LMVED-TD (OGE 25 Aug 76) 5th Ind

SUBJECT: Lake Pontchartrain, Louisiana, and Vicinity, Lake Pontchartrain  
Barrier Plan, General Design Memorandum No. 2, Supplement No. 5A,  
Citrus Lakefront Levee, IHNC to Paris Road

DA, Lower Mississippi Valley Division, Corps of Engineers, Vicksburg,  
Miss. 39180 1 Mar 77

CITRUS LAKEFRONT LEVEE  
IHNC TO PARIS ROAD  
RATING CURVE  
12" x 40' LEVEE  
DRAINAGE CULVERTS

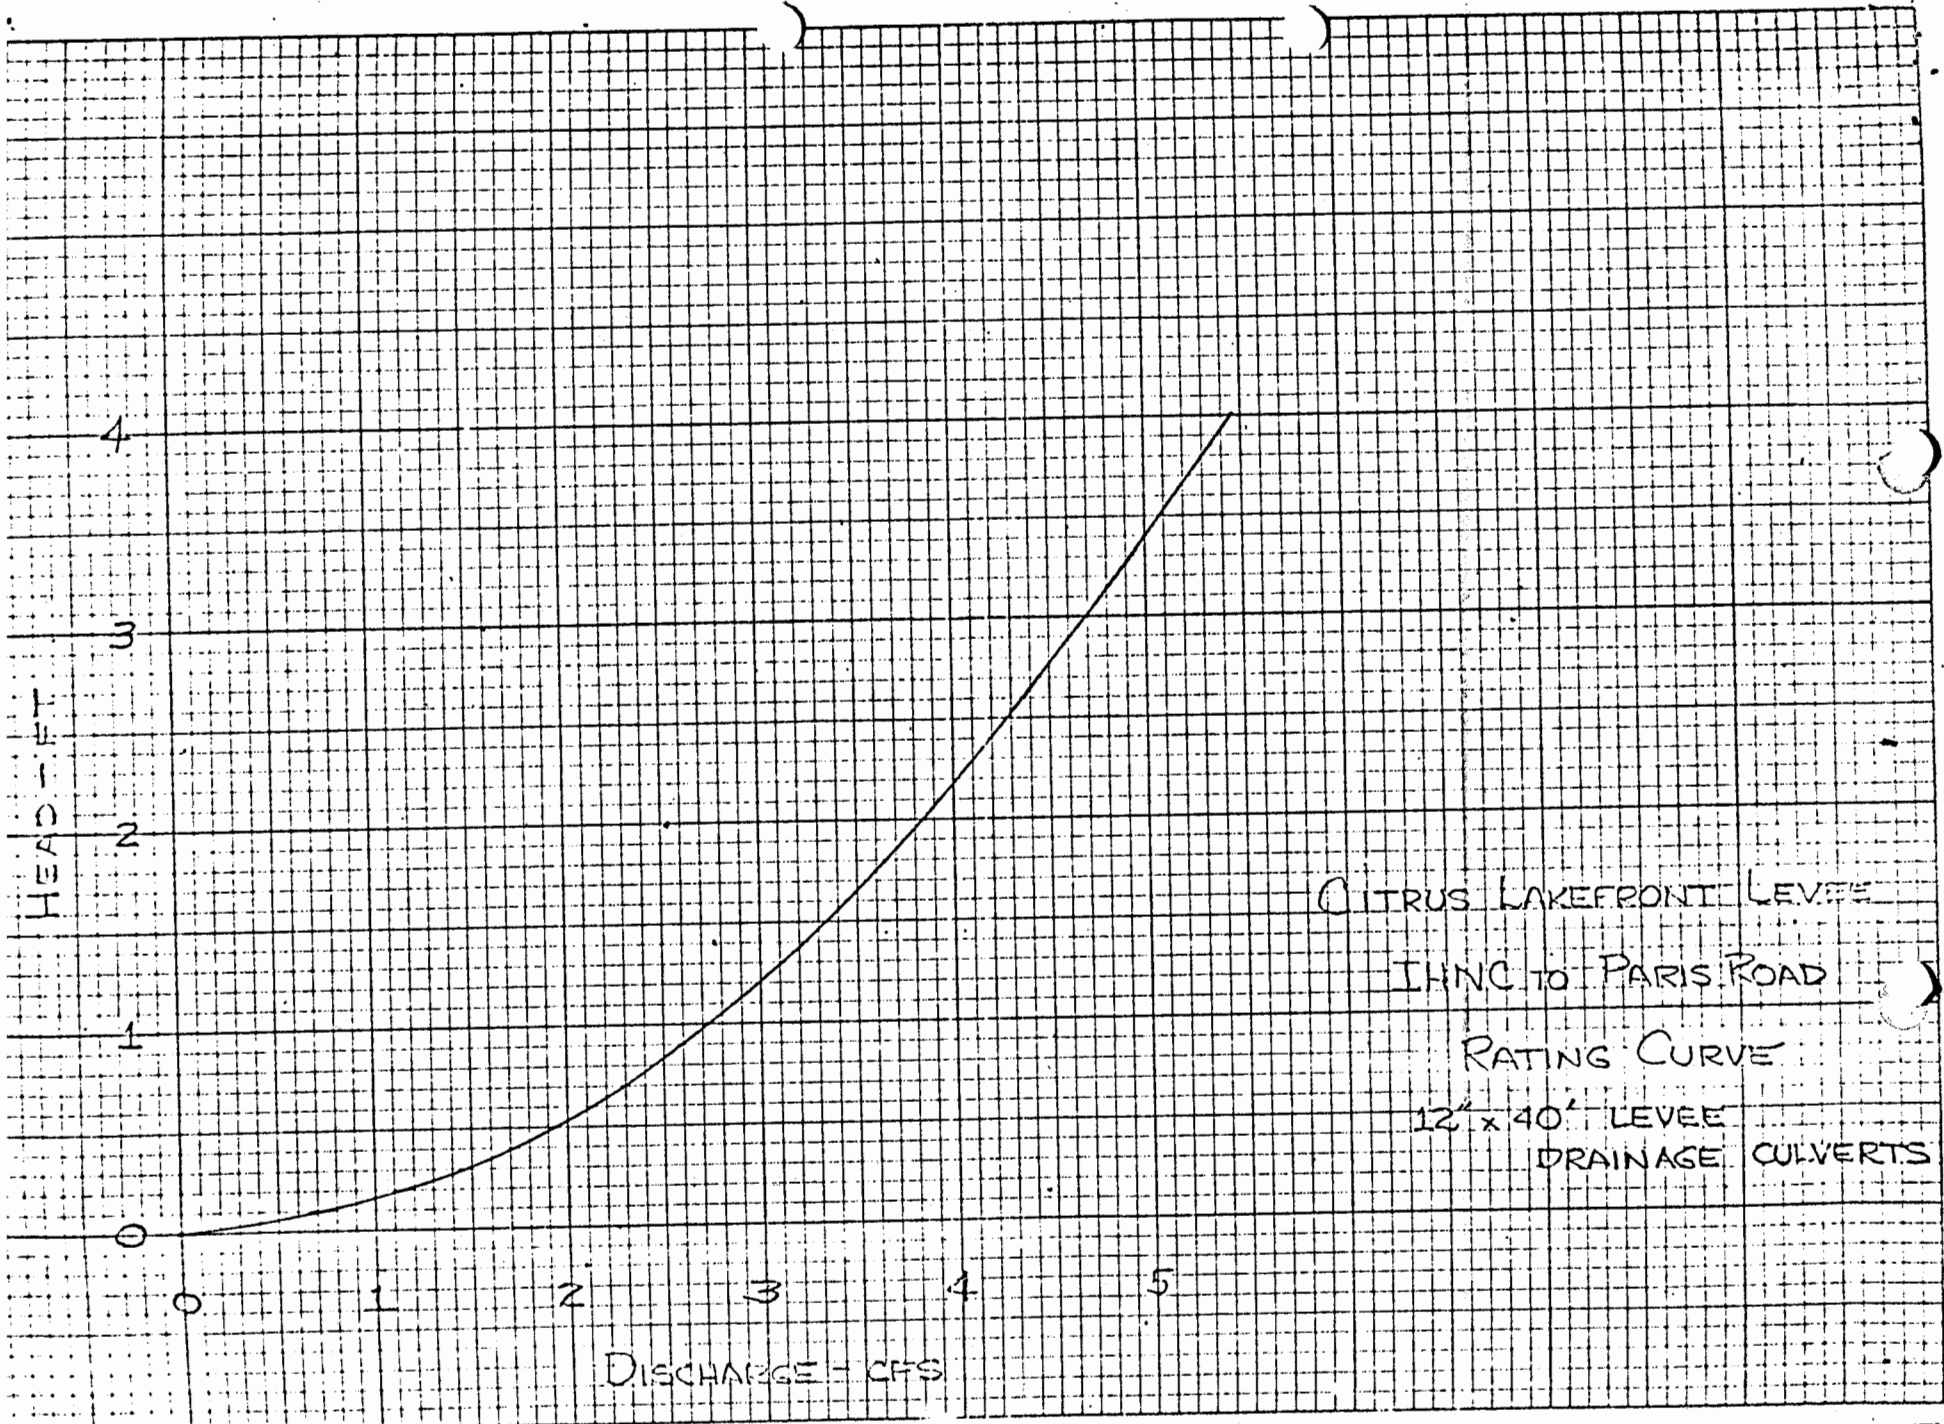
b. Drainage culvert rating curve. A rating curve for the embankment drainage culverts was computed using the orifice flow equation,  $Q = CA(2gh)^{0.50}$ , where  $Q$  is the discharge in c.f.s.,  $C$  is the discharge coefficient,  $A$  is the

cross-sectional area in square feet and  $h$  is the differential head, in feet, on the culvert. Using submerged outlet conditions, an entrance loss of 20 percent of the velocity head in the culvert and a Manning's "n" value of 0.023 the friction losses were evaluated and a "c" value was computed to be 0.43. The rating curve is shown on plate \_\_\_\_.
